M54 to M6 Link Road

**8.8 LIU(C) Draft Statement of Common Ground with
Robert Edward Rowe**

Regulation Number	Regulation 5(2)(q)
Planning Inspectorate Scheme Reference	TR010054
Application Document Reference	8.8 LIU(C)
Author	M54 to M6 Link Road Project Team and Highways England

**FENCING
SHEET 4 OF 10**

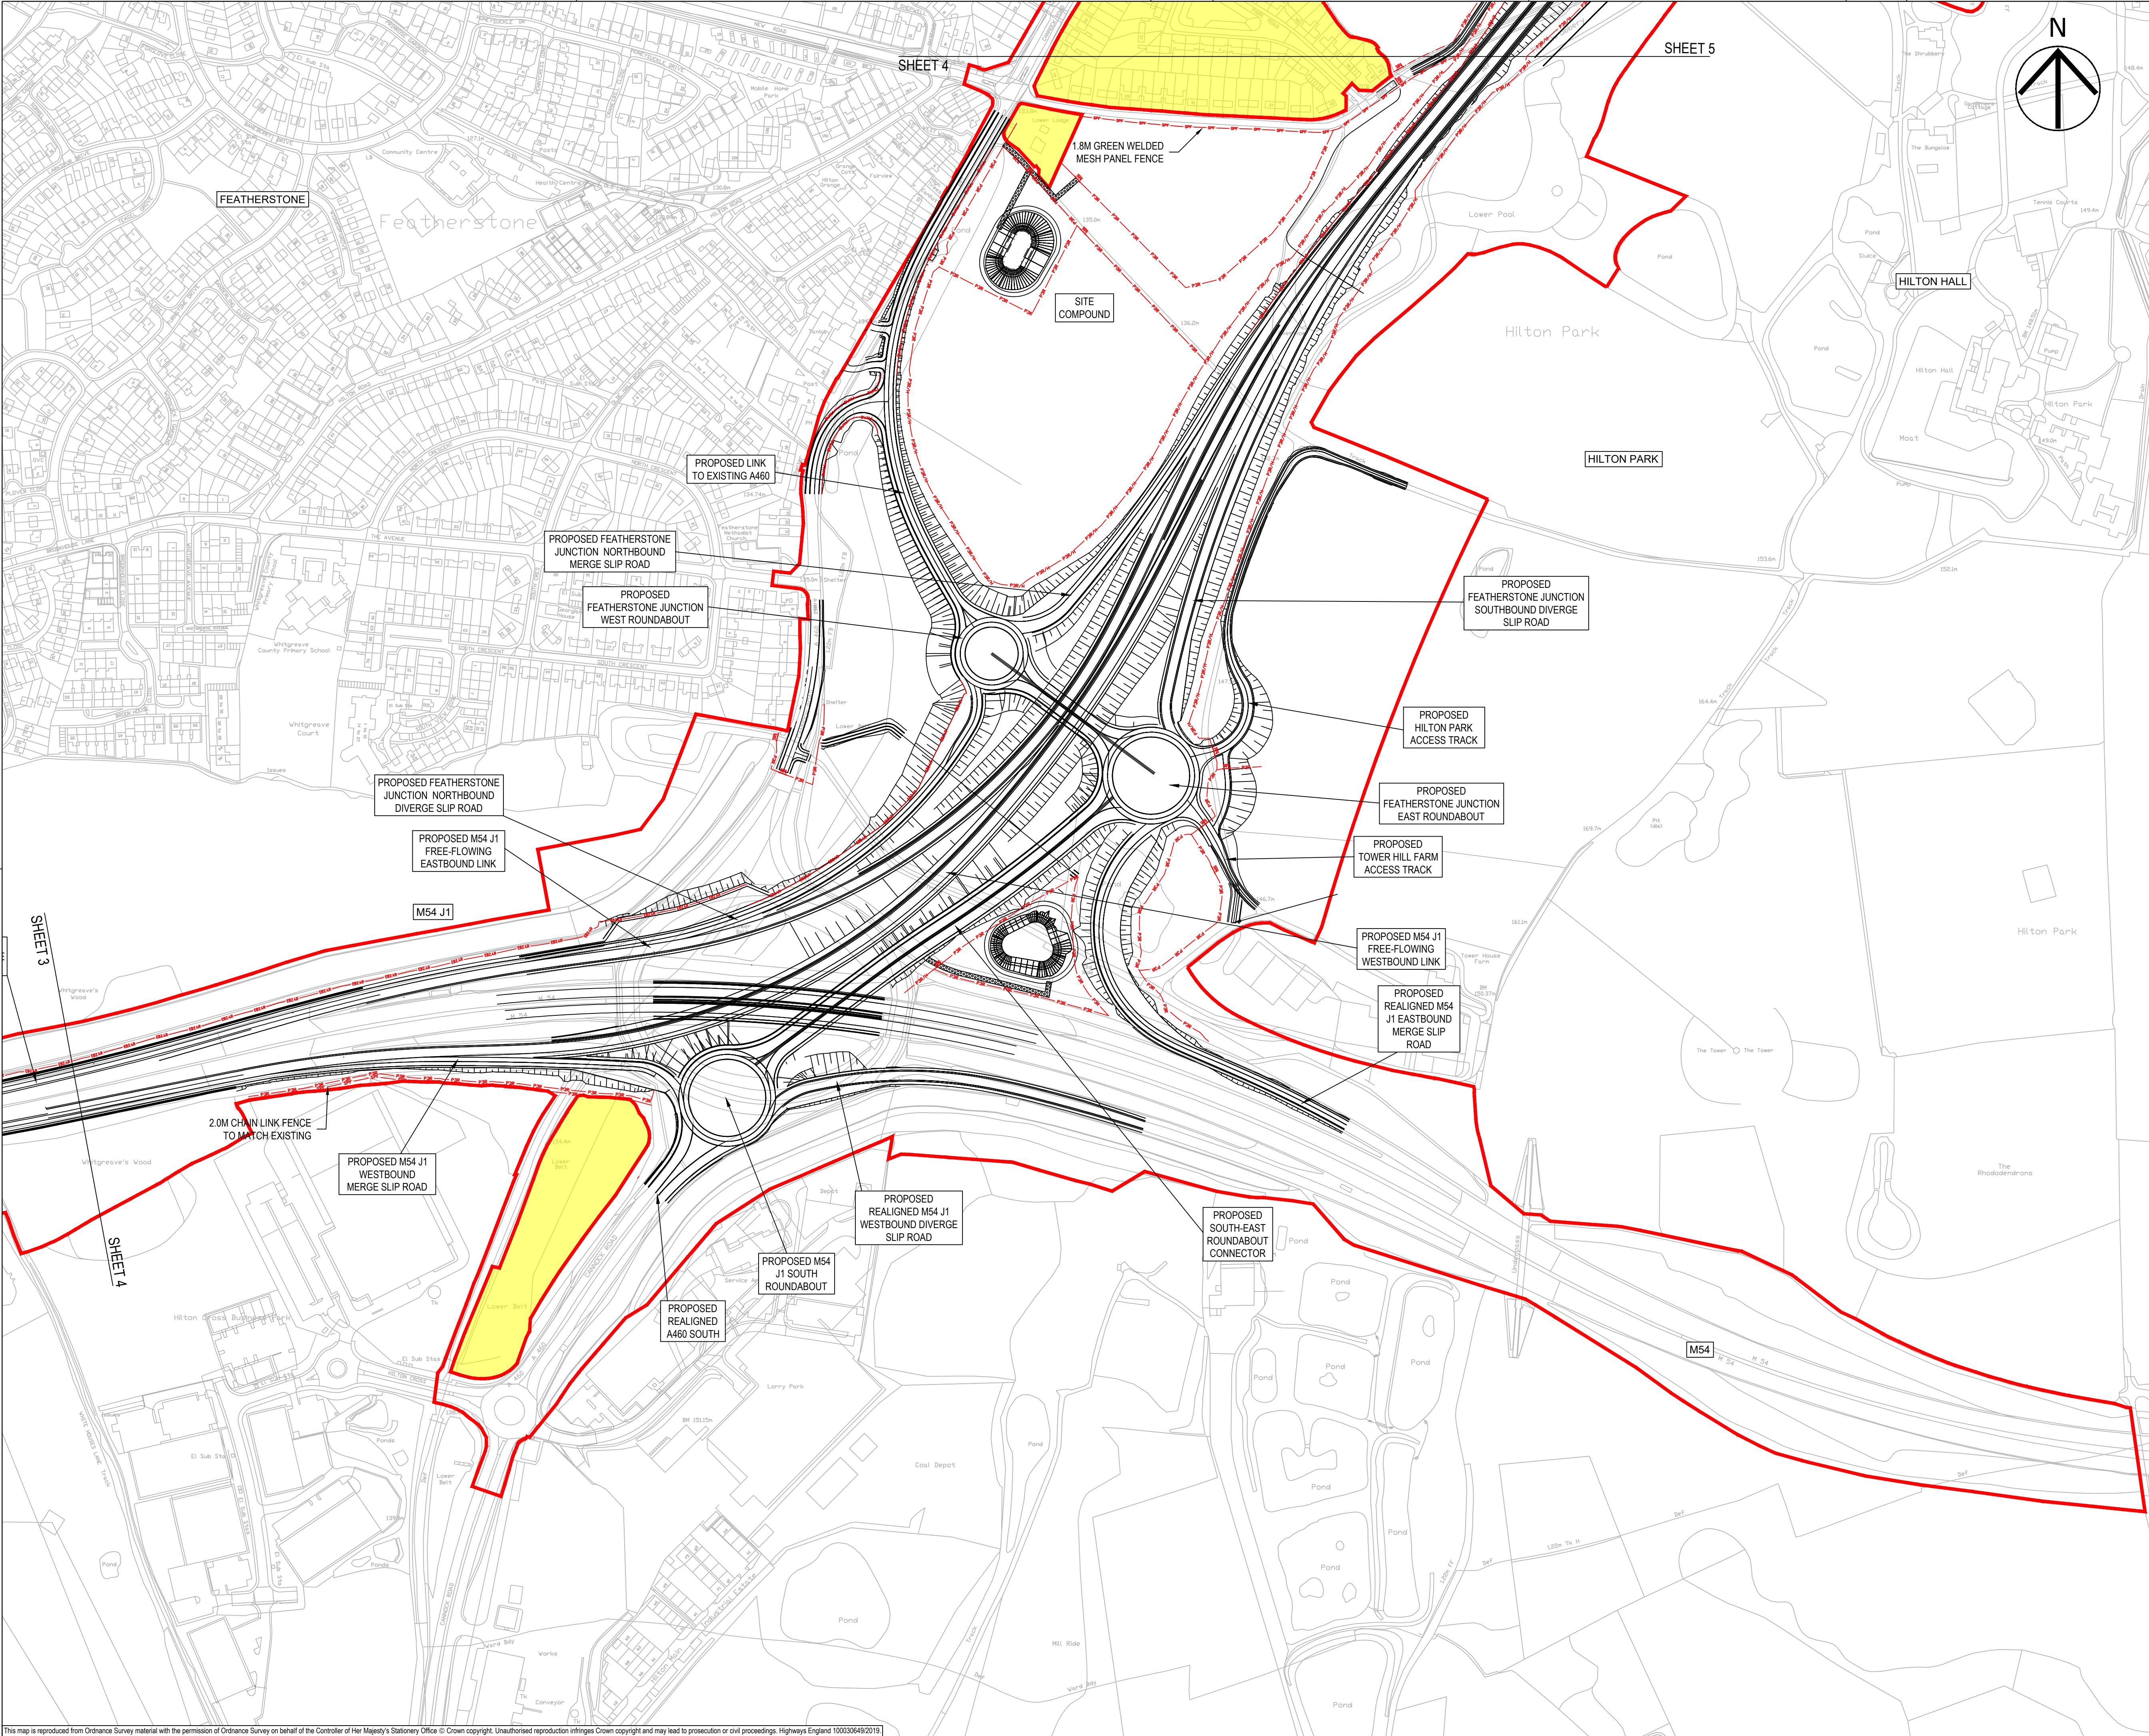
Document/Meeting	Landowner Comment	Highways England Response	Status	Agreement likely ¹
Landowner meeting 4th November 2019	Internal northern access track required to remove need for farm vehicles to use public highway.	An internal access track has been added to the design.	Agreed	Agreed
	Private accesses from roundabout requested to be gated.	Highways England can confirm the private access off the proposed new A460 roundabout to Tower House Farm will be gated. See Appendix B for the fencing drawing (Ref [HE514465-ACM-HFE-Z2_SW_PR_Z-DR-CH-1004]). The exact specification of the gates is to be confirmed following detailed design.	Agreed	Agreed
